**Item 3.****Development Application: 67-69 Murray Street, Pyrmont**

File No.: D/2017/1348

**Figure 10:** A section through the development showing the 25m height trigger.

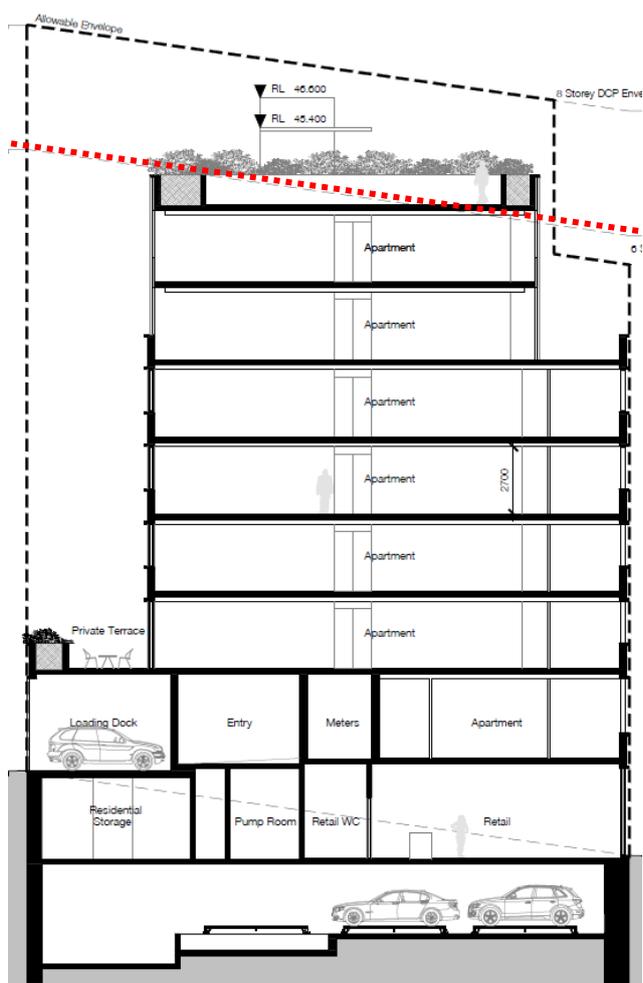
44. The proposal has a height of 28.75m and these clauses apply.
45. A small section of the proposal exceeds the 25m competition / DCP trigger. This includes a small portion of the upper level apartment, the parapet to the roof top terraces and the lift overrun. This is shown in Figure 10 below. It is noted that the proposal does not exceed the 30m height of buildings control for the site.

- (b) The requirement is only triggered by a minor incursion of the building beyond the 25m height trigger. The permitted height for the site under LEP is 30m. The proposed elements of the building above 25m are the parapet to Murray Street, and the lift overrun and stairs, which provide access to rooftop open space areas;

**Figure 11:** The roof top floor plan. It is recommended that these areas be joined to form one compliant area of communal open space.

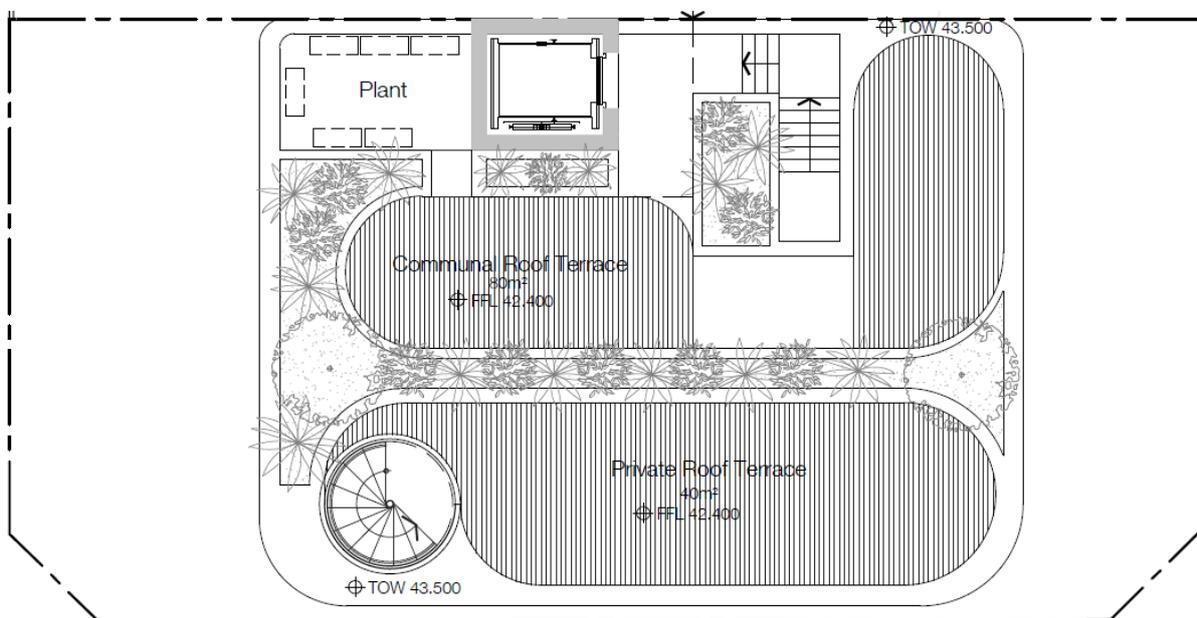
- 51. Part 3D of the Apartment Design Guide (ADG) requires 25% (72.5sqm) of the site area to be provided as a communal open space area.
- 52. The application proposes a communal roof terrace (as shown in Figure 11 below) which provides only 40sqm as usable area, with the remainder being planter boxes. This does not satisfy the ADG requirements.
- 53. A 40sqm private roof terrace servicing unit 7.01 is also proposed at rooftop level.
- 54. A condition is recommended that the private roof terrace be assimilated into the communal area. This would then nearly double the size of the communal space to a compliant 72.5sqm.

57. A condition is also recommended that the design be modified so that a 12sqm private balcony with a minimum depth of 2.4m is to be provided to unit 7.01 in the south-eastern corner and located within the existing floorplate. The location of the balcony in the south-eastern corner is consistent with the other balconies within the building and does not result in unreasonable privacy impacts to neighbouring properties. This is illustrated in Figures 11 and 12 below.

**Figure 12:** The Level 7 (Unit 7.01) floor plan, illustrating the recommended balcony location highlighted. The spiral staircase would also be removed allowing increased living space.

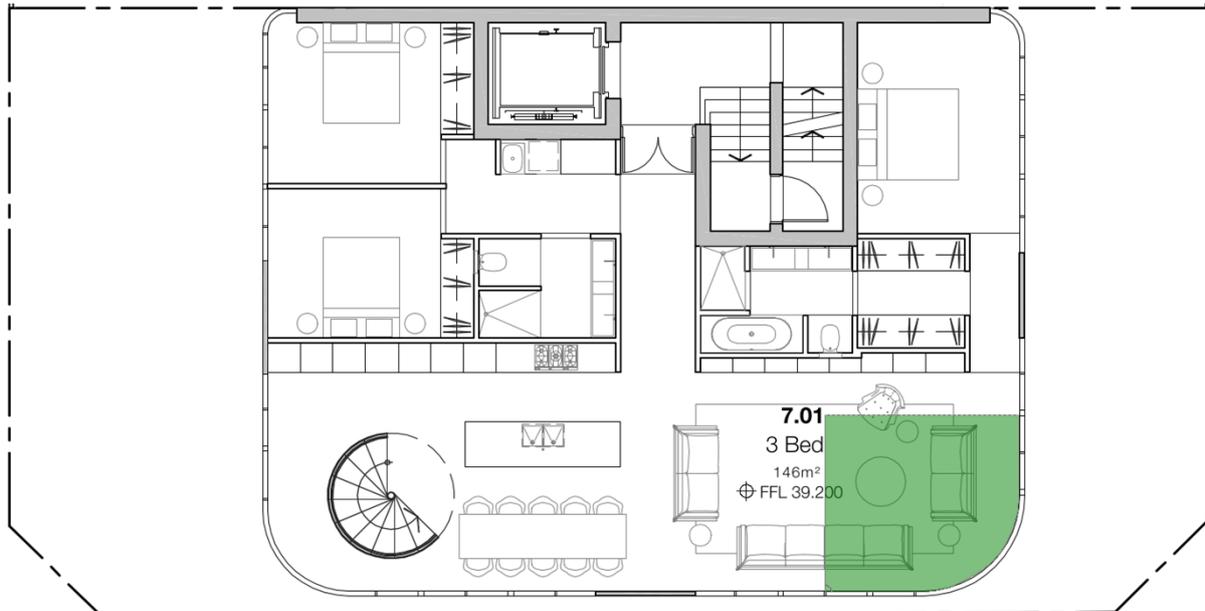
55. Unit 7.01 contains three bedrooms and bathrooms (as shown in Figure 12 below) and the ADG requires a minimum size of 95sqm, with a minimum private open space area of 12sqm. The proposed unit size is 146sqm, and therefore there is sufficient space to re-design the apartment to provide a 12sqm balcony within the existing floor plate.

56. This will allow the private open space for Unit 7.01 to be located directly adjacent to the living room which satisfies the requirements of Part 4E (Private open space and balconies) of the ADG. Additionally, the recommended design modification will provide an amenity benefit by removing the spiral stair which takes up a large portion of the western part of the living area, which is also adjacent to the facade that receives 2+ hours of solar access at midwinter.

Figure 13: A section showing the building separation across Harwood Lane.

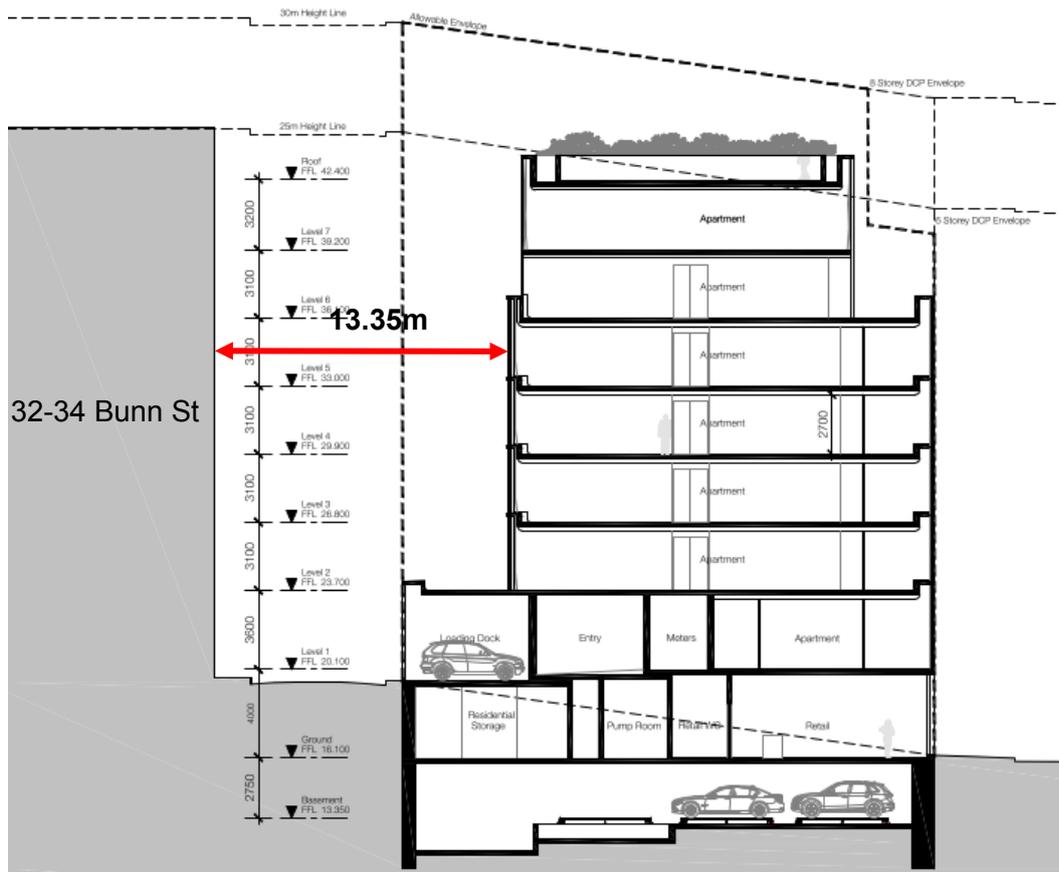
60. The application proposes 13.35m of building separation (as shown in Figure 12 below) which is inconsistent with the requirements of the ADG. It is acknowledged that it is difficult to achieve the required building separation due to the lack of setback provided by the building opposite. Notwithstanding this, there has been insufficient mitigation of privacy impacts through the design of the building. In particular the northern bedroom on the western facade has full window coverage to its western wall. This will result in a poor amenity outcome for both the future occupants of the site and the occupants of the neighbouring site.

61. A condition is recommended that horizontal external operable louvres are to be provided to the southern window on the western facade of the northern bedroom across Levels 2-7 (as shown in Figures 14 and 15 below). This will minimise privacy impacts between the site and existing residential flat building at 32-34 Bunn Street.

**Figure 15:** Location of recommended privacy louvres.

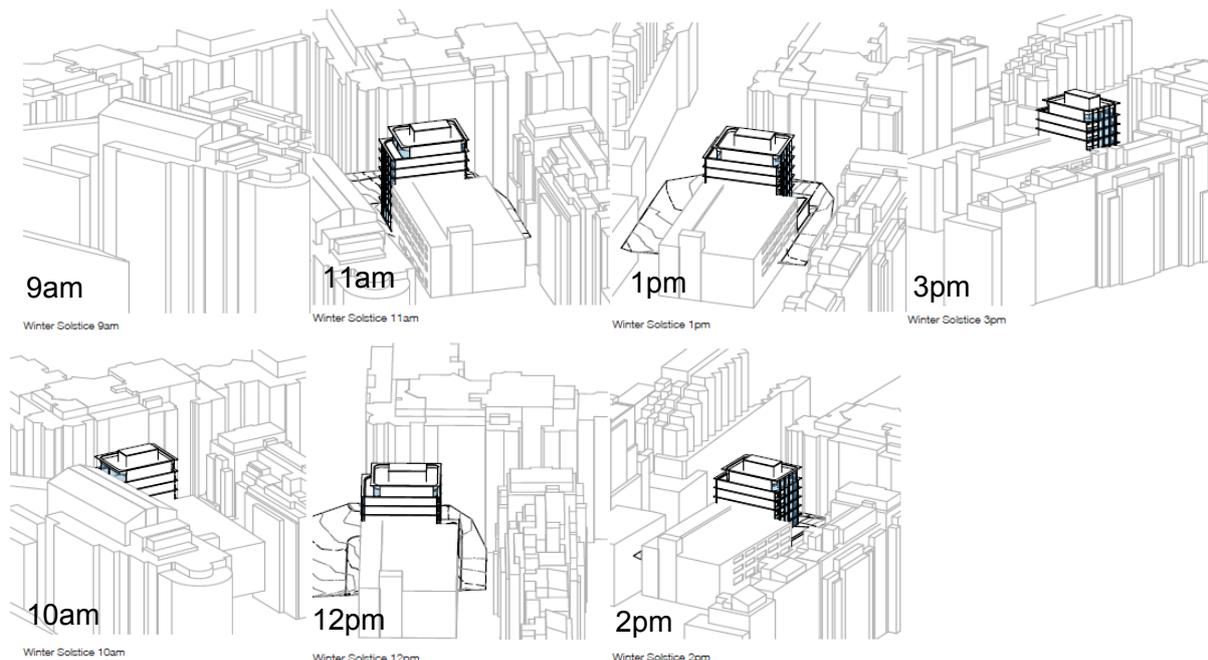
62. There is a private terrace of 36sqm in size located at the rear of Level 2. The provision of a 1.6m wide planter that runs the length of the rear of the site will minimise privacy impacts to the opposite side of Harwood Lane.

**Figure 17:** Location plan of views from 1-29 Bunn Street showing communal roof terrace (arrows) and location of Lot 114 (highlighted).

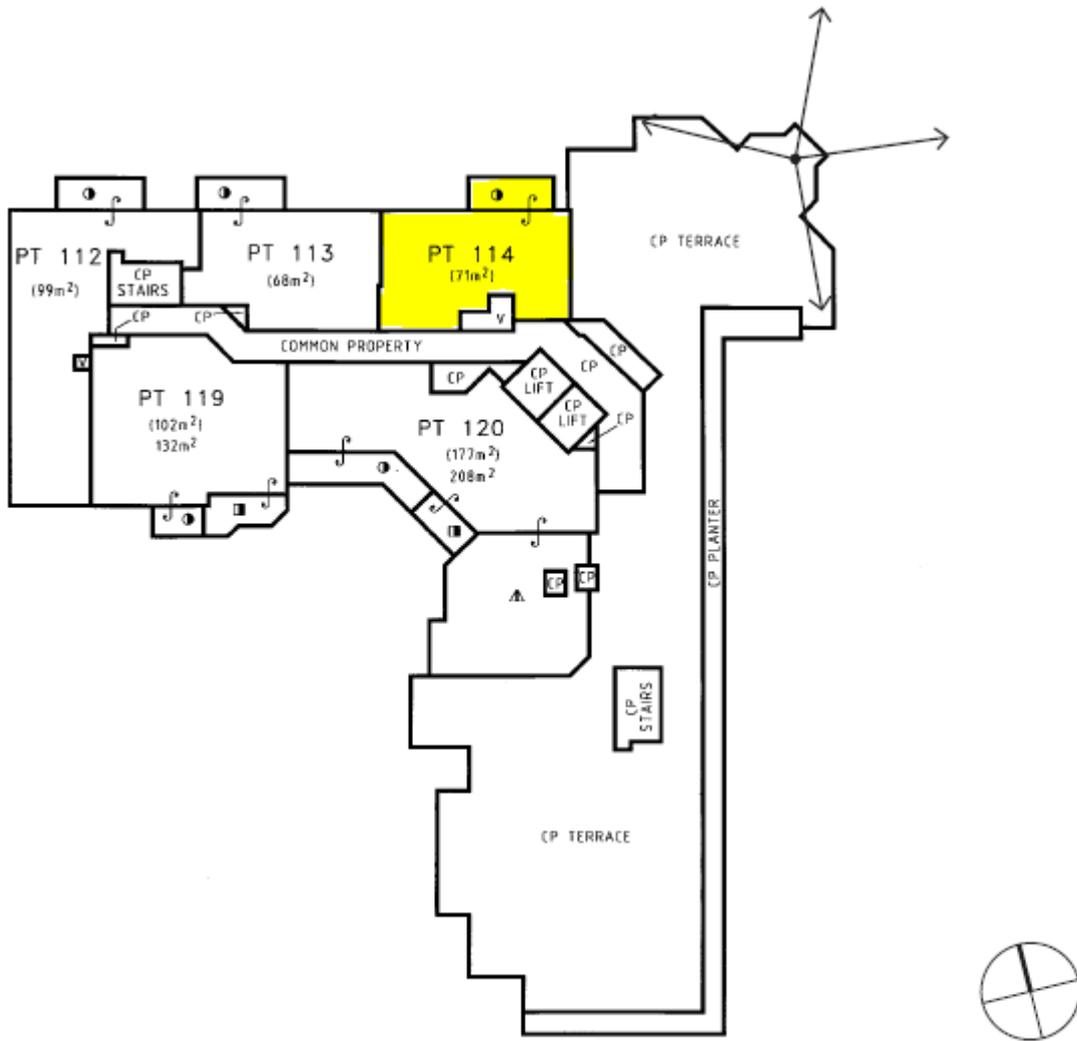
70. Submissions were received objecting to the proposal due to the loss of harbour and district views from the north facing apartments and the communal roof terrace of 1-29 Bunn Street. Figure 17 below shows the location of the communal roof terrace and Lot 114, which is a double storey apartment with living room on Level 10 and bedrooms on Level 11. Lot 115 is located below the communal roof terrace.
71. These views are currently obtained by looking across Bunn Street and over the subject site towards the north.

73. The proposal is consistent with the height, floor space and building setback controls, and the views from the apartments are partial views. There is no other reasonable design alternative that would allow for the retention of these views and it is considered unreasonable to require further modifications to the building.
74. The impact to the communal roof terrace is considered to be acceptable, given that it is a partial view loss and the roof terrace currently achieves views towards the city which will not be impacted by the proposal.
